OUTLINE OF CHANGES TO APPROVED SCHEME
(REF:0221328)

REV A - 22.10.2024

SITE LAYOUT PLAN

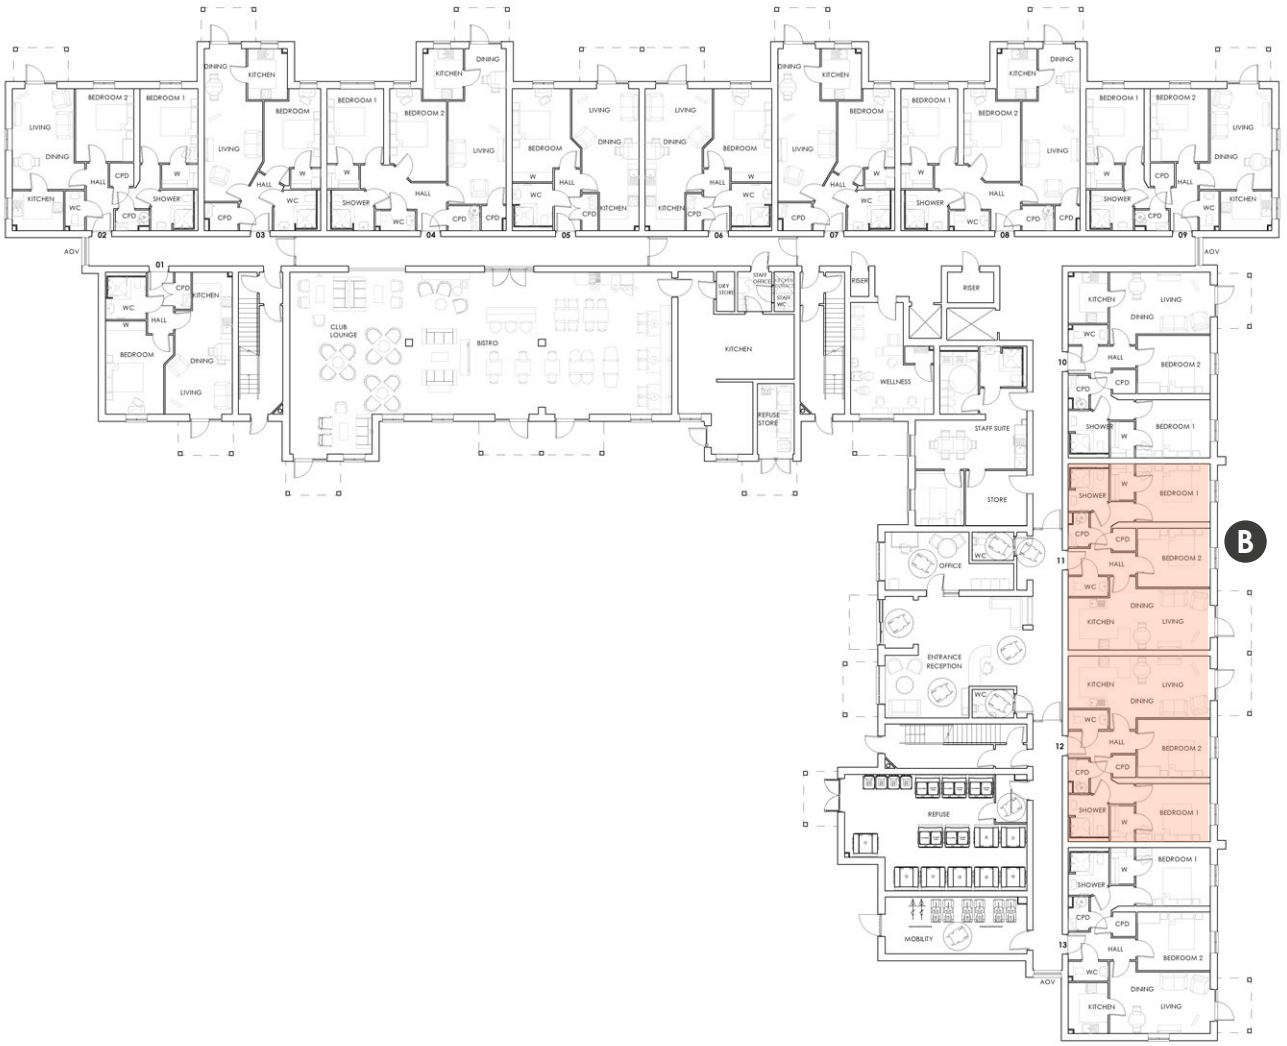
- A** Substation repositioned to southeastern corner of site, now accessed from Church Walk.
- B** Projecting units in central portion of eastern elevation to Church Walk aligned / projection removed, replaced with brick details.
- C** Opaque balustrades to balconies replaced with glazed panels.
- D** Some window depths and location of transoms altered to improve proportions.
